Spare Parts Requirements - Transfer Case/Transfer Case Control Unit: Note link between transfer case and control unit software (26/18)

Revisions: This bulletin replaces bulletin dated April 17, 2018.

Model Year: **As of 2014 up to 2018**

Model Line: **Macan**

In the control unit overview ⇒ select '**All-wheel drive**' control unit ⇒ 'F12' ⇒ '**Extended identifications**':

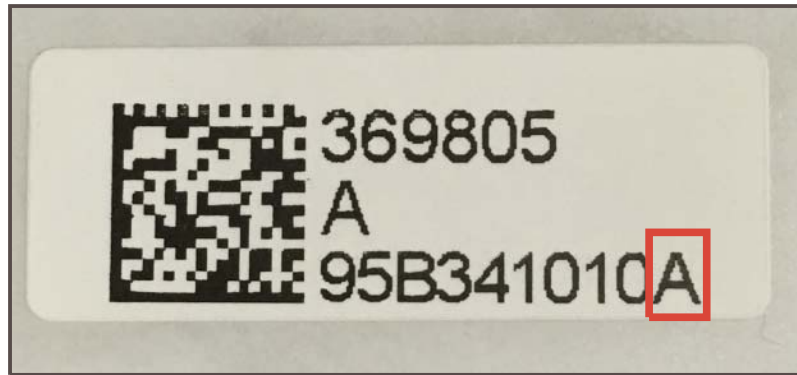
"Gas nitrocarburizing (GNC)" is now used to coat the clutch plates on the transfer case.

The software in the related transfer case control unit must be updated accordingly.

⇒ A mixed installation – transfer case with GNC plates and control unit software with an old data version or vice versa – is not permitted.

Transfer case without GNC (old)	Transfer case with GNC – NEW –
Display in the PIWIS Tester: ⇒ Porsche Part No. of control unit • after commissioning:	95B.927.755.BJ	95B.927.755. CB
Display in the PIWIS Tester: ⇒ Software version of control unit • after commissioning	1204	1360
- Sticker on transfer gear (⇒ <i>Part number sticker (on transfer case)</i>) - and lasered on the underside	95B.341.010	95B.341.010. A
Display in the PIWIS Tester: ⇒ PR number* in the vehicle order (Additional menu – •F7")	- without -	LU2 – Transfer gear reinforced
Porsche Spare Parts Catalog (PET2)	95B.341.010	95B.341.010. A

Transfer gear with control unit

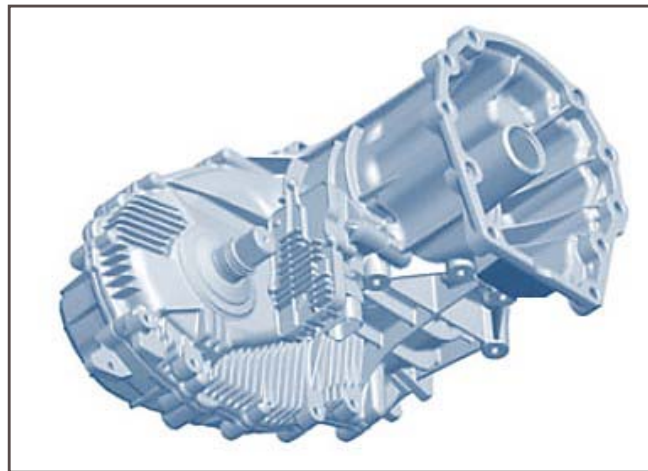
Variant 1: **Replacing transfer case and transfer case control unit** (together, ⇒ *Transfer gear with control unit*).

The relevant transfer case control unit is already fitted on a new transfer case. **PIWIS Tester 3** selects the correct data record and sets the PR number LU2 automatically.

Part number sticker (on transfer case)

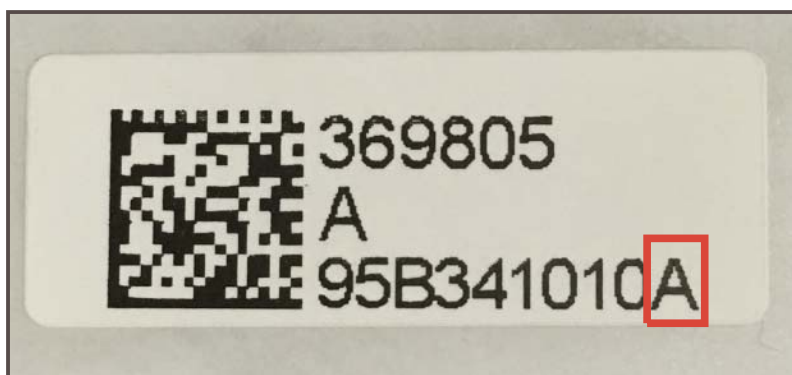
Part number on the new (replacement/reconditioned) transfer case (sticker with part number ⇒ *Part number sticker (on transfer case) -Index-*) must be checked:

- a) **Part number** of the new **transfer gear does not correspond to the new type** ⇒ **Part number ends with 010 and has no index** (no letter, e.g. "A")

- b) Part number of the new transfer case corresponds to the new type ⇒ **Part number has index letter** (⇒ *Part number sticker (on transfer case)-red frame- "A"*)

⇒ **The transfer case on the new PDK must be replaced by a transfer gear with the new part number (with index letter).**

⇒ **The transfer case can remain on the new PDK and can be installed in the vehicle.**
